STAFF RECOMMENDATION

NCPC File No. 6546

**FORT LESLEY J. McNAIR,
NATIONAL DEFENSE UNIVERSITY EXPANSION
PHASE II- LINCOLN HALL
4th and P Streets, SW
Washington, DC**

January 27, 2005

**FIRST FLOOR PLAN OF LINCOLN HALL ADJACENT TO MARSHALL HALL,
WITH LOCATION OF ENTRY DRUM AND DETAIL SECTION**

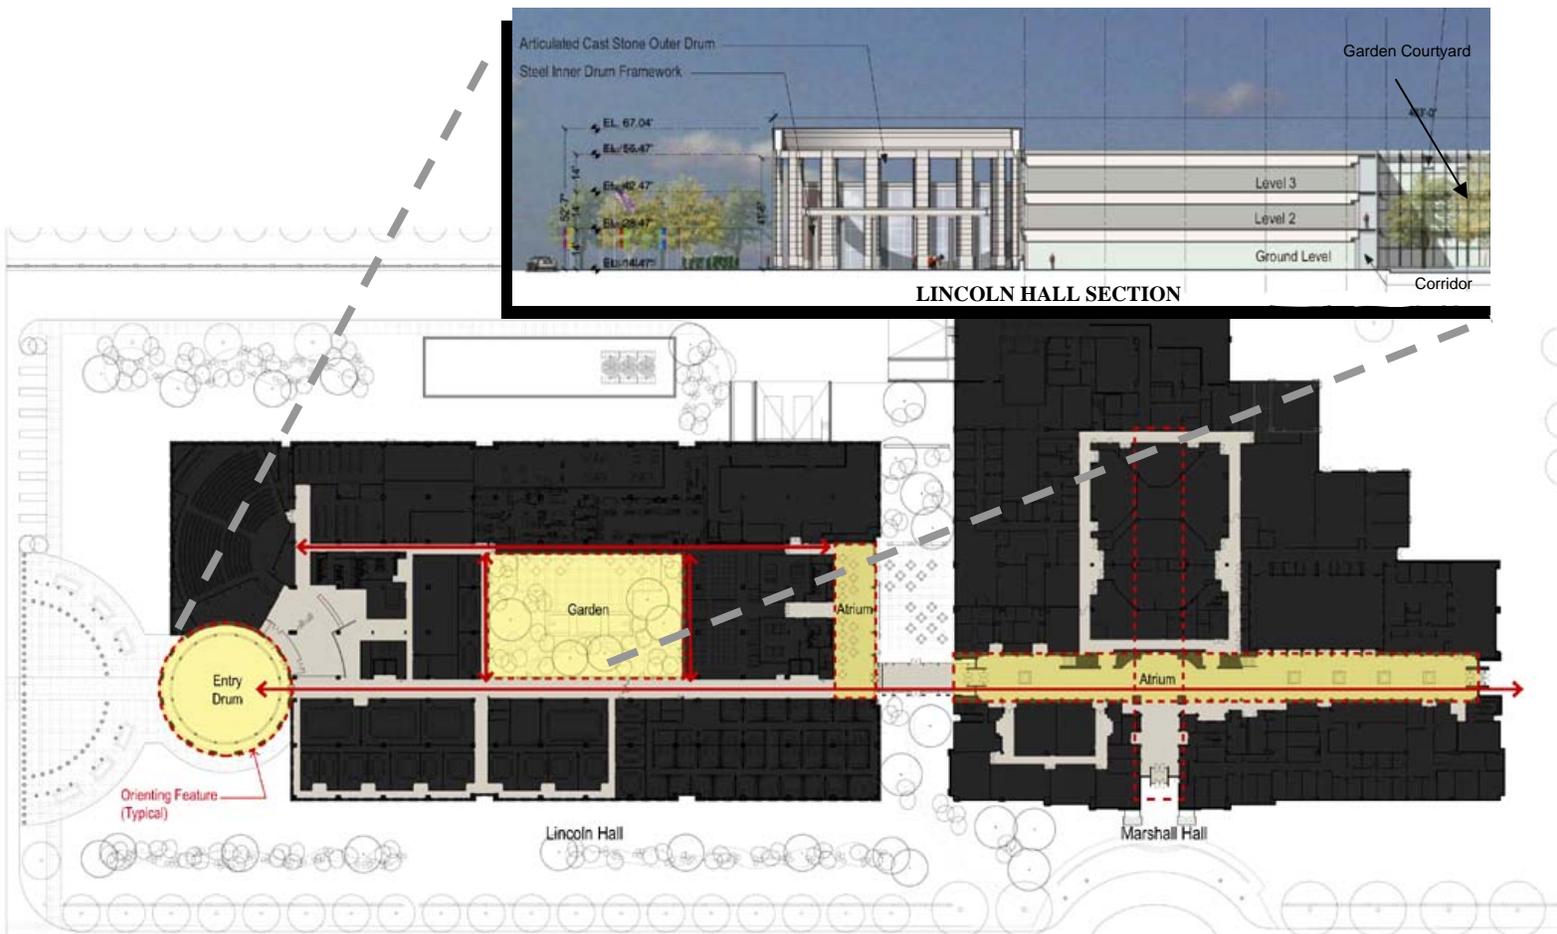
The north entrance plaza and circular entrance feature provides a symbolic reference to military cadence, rhythm and order, while allowing a central distribution and check-in point that will serve both the conference functions and educational activity areas. The north entry circular “drum” also fully defines a ceremonial space identified in the building program that will provide an opportunity for features such as inscribed stone memorializing, banners, and flag displays. The location will facilitate occasions for award ceremonies, a venue for press conferences, and a welcoming space for visiting dignitaries and the President that will be visibly situated near the new east entrance to the Fort once that element is established.

LINCOLN HALL 2ND STREET ELEVATION

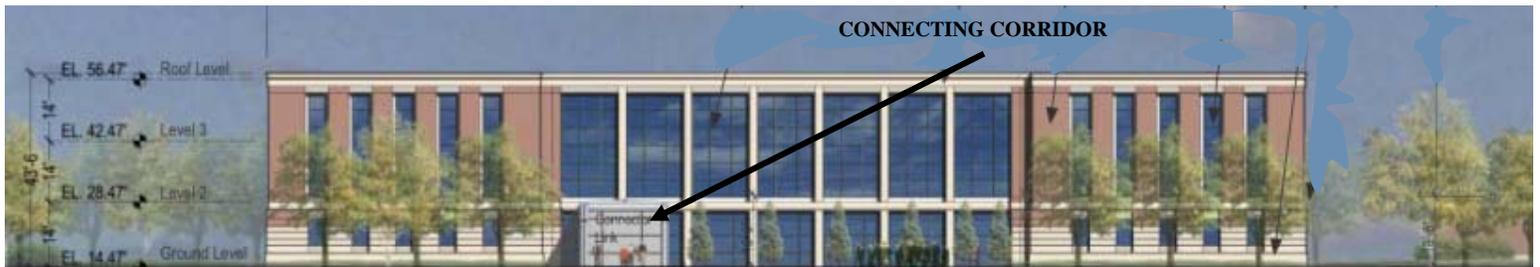
The revised project design responds to the issues by continuing to maintain an open space character to the building's main entrance which is oriented toward the 2nd Street corridor. In December 2004 the Army meet with the District Department of Transportation and the Office of Planning to review the revised building design as it pertain to the AWI and the east gate concept. The building is modulated along the east façade and provides windows and a low profile which minimizes the building's exterior wall mass as viewed from 2nd Street.

SECTIONAL PERSPECTIVE VIEW OF CONNECTING CORRIDOR

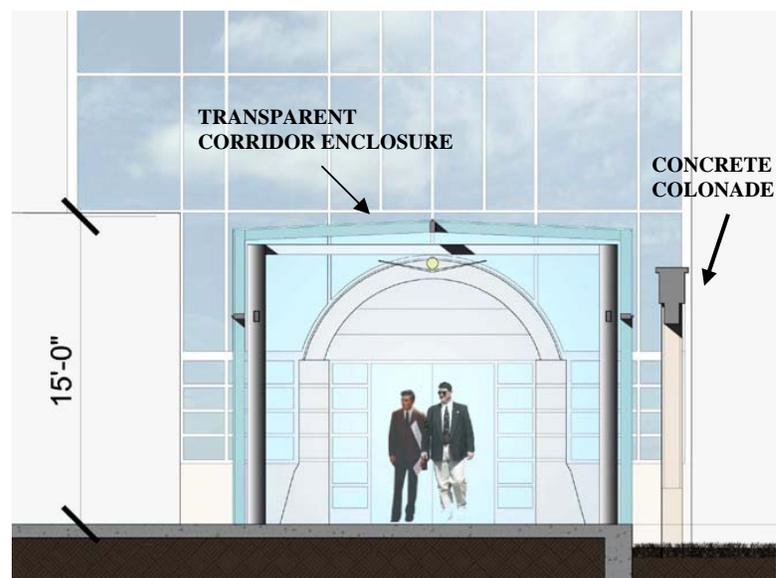
- Modify the connection between the NDU Expansion and Marshall Hall so that it connects to all floor levels within Marshall Hall or becomes a full-height vaulted space.
